NOTICE TO ALL CONTRACTORS:

Proposal #27: 6663-02-71
Rib Mt Drive (CTH N) Ped Facility
Town of Rib Mountain
Local Street
Marathon County

Letting of April 11, 2017

This is Addendum No. 01, which provides for the following:

Addendum No. 01
 ID 6663-02-71 &
 ID 6999-18-72
 Revised Sheet 44
 March 28, 2017

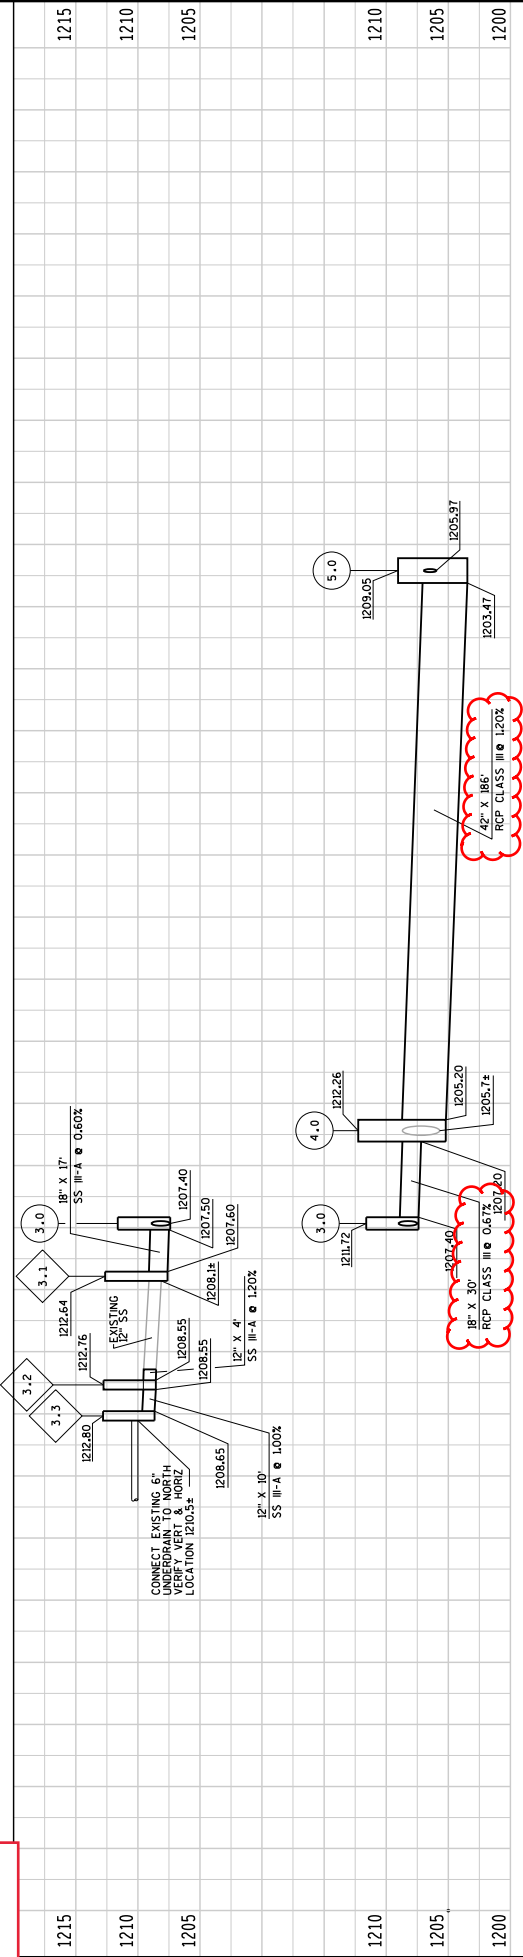
Revised Plan Sheets	
Plan Sheet	Plan Sheet Title (brief description of changes to sheet)
44	Storm Sewer (revised the callout on the profile view of the pipe to say RCP Class III for the runs from 3.0 to 4.0 and from 4.0 to 5.0)
49	Storm Sewer (revised the callout on the profile view of the pipe to say RCP Class III for the runs from 5.0 to 6.0, from 6.0 to 7.0, and from 6.1 to 42" SS; added callout for "Storm Sewer Pipe Connection from 6.1 to 42" SS)
151	Miscellaneous Quantities (revised storm sewer pipe quantities for the described changes on sheets 44 and 49)
